<b>Model</b>	SS930/950/915, Ges5130/5170/5210, Rex1060/1070/1140	<b>Volt/Hz</b>	<b>Date of Modification</b>	<b>Serial Number</b>
<b>Modified Article</b>	Upper Master Feed Roller & Upper Reverse Roller			
<b>Reason for Modification</b>	To increase the master paper feeding ability

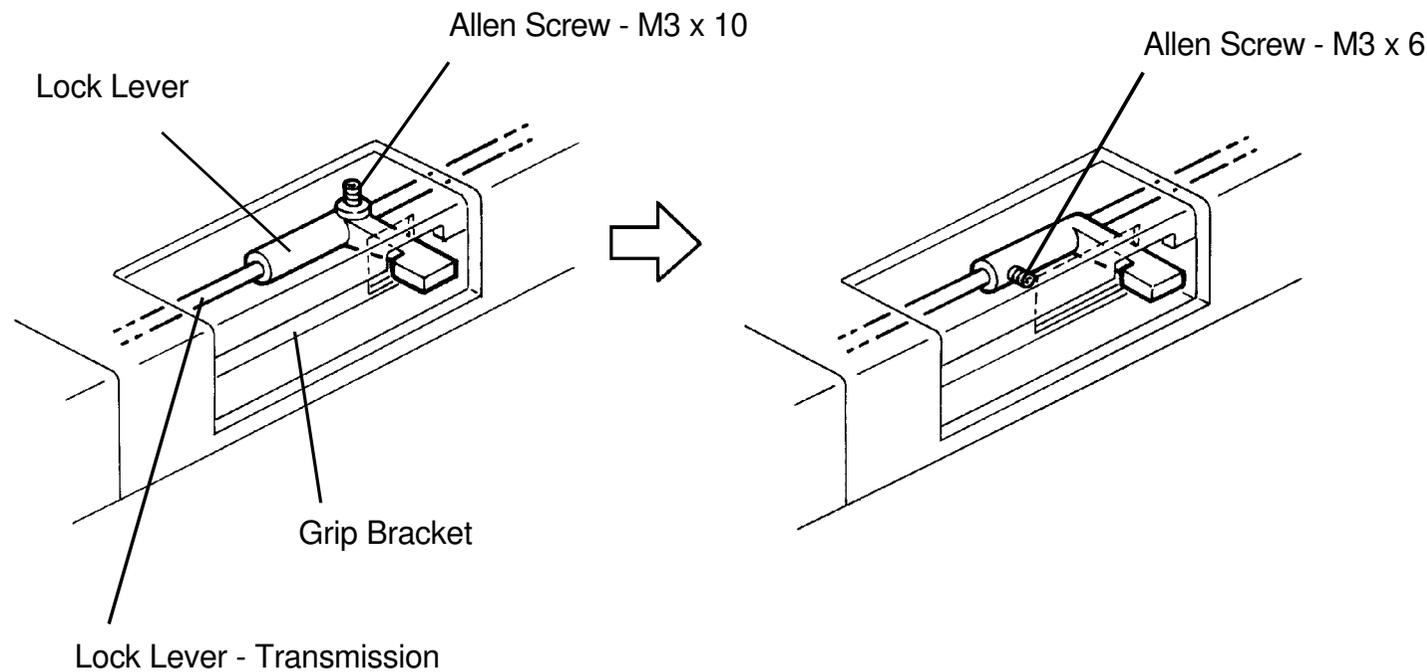
In the present machines, it is difficult to tighten the screw fixing the lock lever to the shaft. It is necessary to remove the scanner unit to access the screw.

To facilitate servicing, the direction of the screw has been changed and the cutout of the bracket has been enlarged so that a customer engineer can access the screw from the cutout of the bracket.

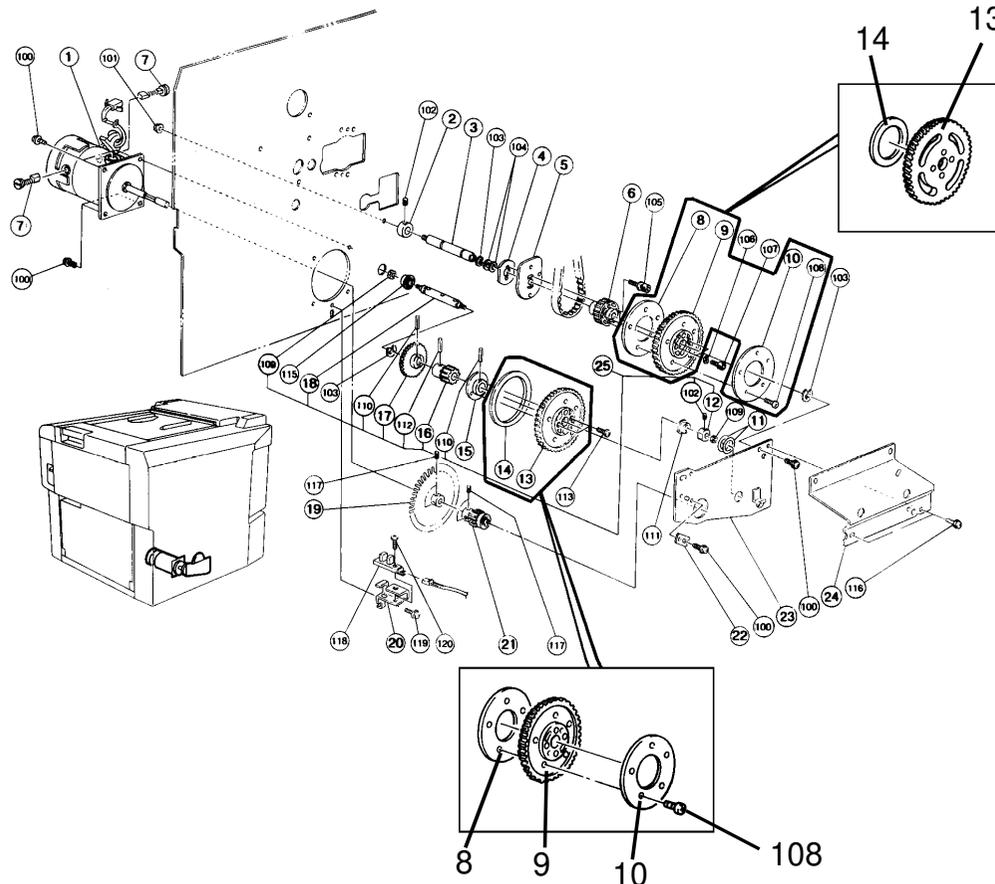
Please correct the illustration on page 9 as shown below.
